PLANNING AND ZONING CASE CHECKLIST

P&Z CASE # H2020-006 P&Z DATE 1 / 1 / CC DATE _____ APPROVED/DENIED _____
ARCHITECTURAL REVIEW BOARD DATE _____ HPAB DATE 10/15/20 PARK BOARD DATE _____

HISTORIC PRESERVATION ADVISORY BOARD APPLICATION

I AM BUILDING A DETACHED 3 CAR GARAGE WITH A STORAGE ROOM.
THE GARAGE IS BEING BUILT ON AN EXISTING DRIVEWAY.

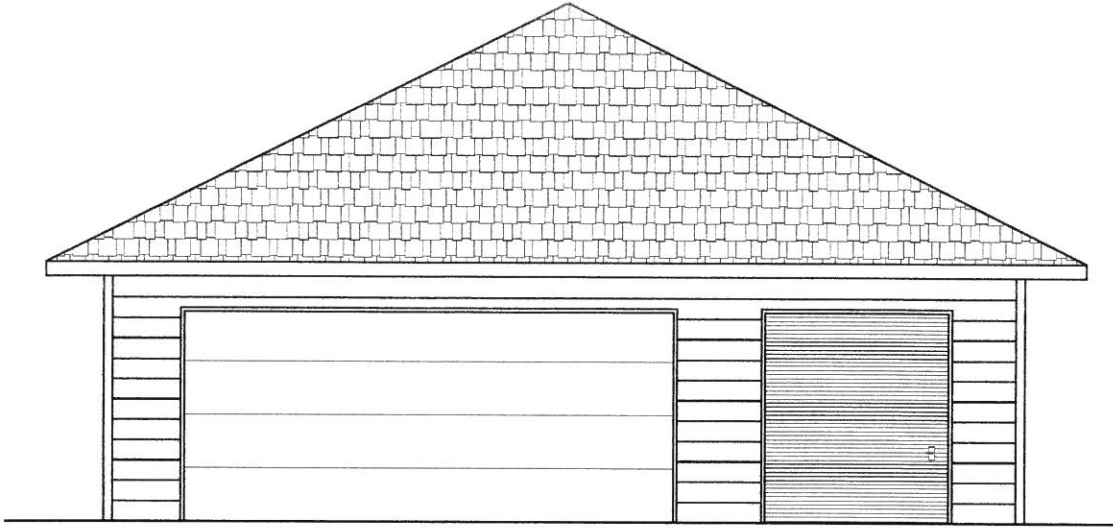
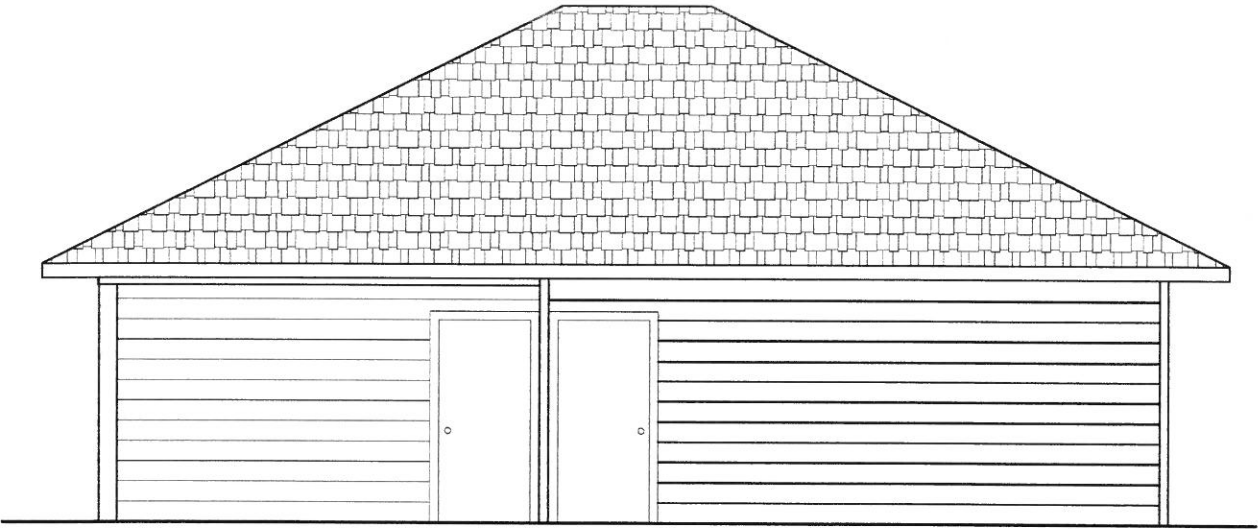
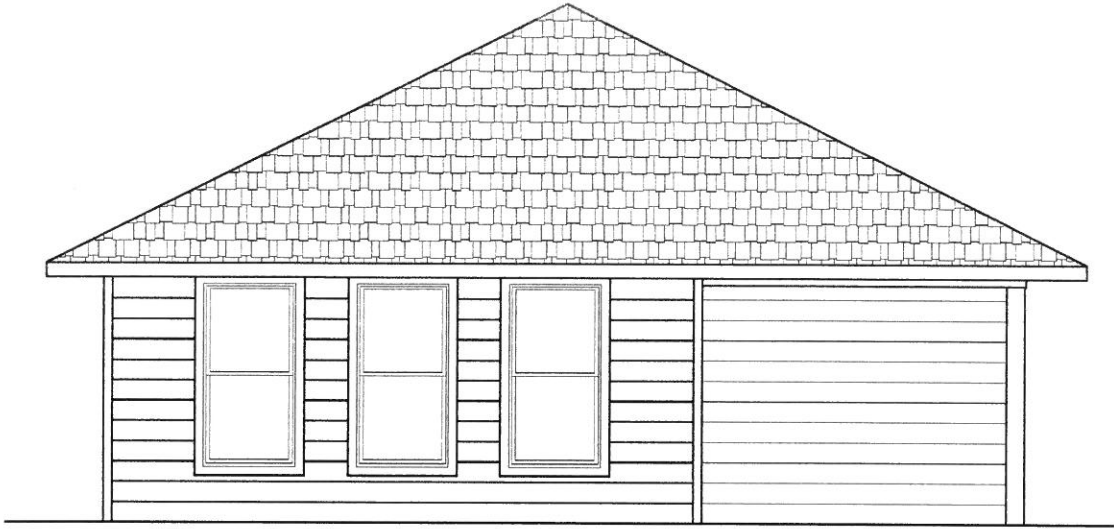
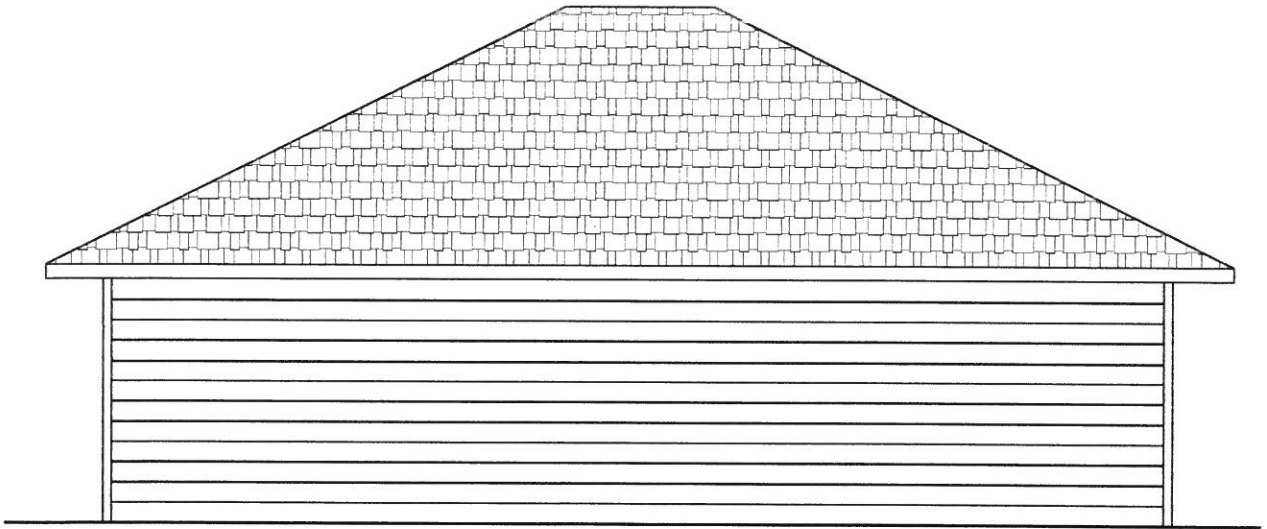
I need to know the height of you proposed detached garage, which if they could be added to the elevations would be ideal.

I need more information on the exterior materials used, including color.
